Access Compliance Report

Public Rights-of-Way

Intersection ID: 13994	Main Street: E_3RD_ST	Cross Street: S_TORRENCE_ST	Location: W
ADA ID: 83ECE922E968	Ramp Type: PerpDiag	Initial Pass/Fail: Fail	Overall Compliance: No
		Severity Score: 30

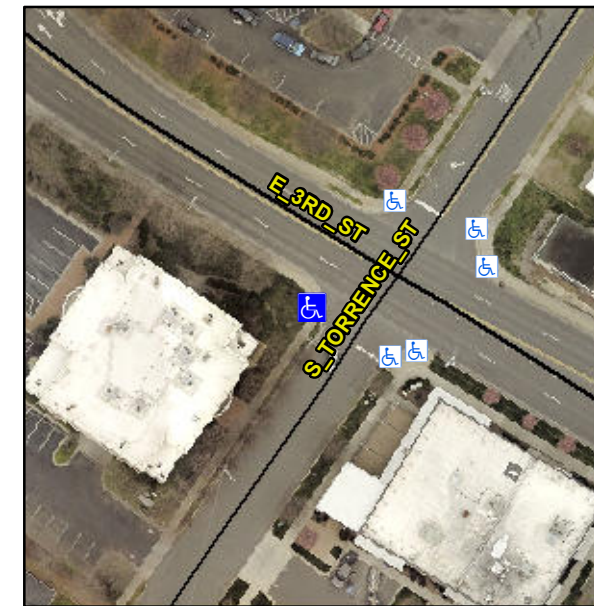
Not Found, R304.5.1, R304.5.3

Compliance	Description	Data	Compliance	Description	Data
N/A	Ramp Length (in)	74.0	Yes	Ramp Slope (%)	5.2
No	Ramp Width (in)	33.0	No	Ramp XSlope (%)	6.3
N/A	Flare Type LT	N/A	N/A	Flare Type RT	N/A
N/A	Flare Slope LT (%)	N/A	N/A	Flare Slope RT (%)	N/A
N/A	Flare Traversable LT?	N/A	N/A	Flare Traversable RT?	N/A
N/A	Landing Length (in)	N/A	N/A	DWS Provided?	N/A
N/A	Landing Width (in)	N/A	N/A	DWS Contrast?	N/A
N/A	Landing Slope (%)	N/A	N/A	DWS Length (in)	N/A
N/A	Landing X Slope (%)	N/A	N/A	DWS Full Width?	N/A
N/A	Landing Curb? (Y/N)	N/A	N/A	DWS Offset (in)	N/A
N/A	Shared Landing?	N/A			
N/A	Gutter Ponding?	N/A	N/A	Gutter Slope (%)	N/A
N/A	Gutter Lip Ht (in)	1.0	N/A	Gutter X Slope (%)	N/A
N/A	Painted X Walk1?	No	N/A	Painted X Walk2?	No
	X Walk 1 Direction	To SE		X Walk 2 Direction	To NE
N/A	X Walk 1 Width (in)	N/A	N/A	X Walk 2 Width (in)	N/A
	X Walk 1 Slope (%)	7.3		X Walk 2 Slope (%)	3.5
	X Walk 1 X Slope (%)	2.6		X Walk 2 X Slope (%)	1.0

Remove & Replace Curb Ramp With Two New Directional Ramps or Equivalent.
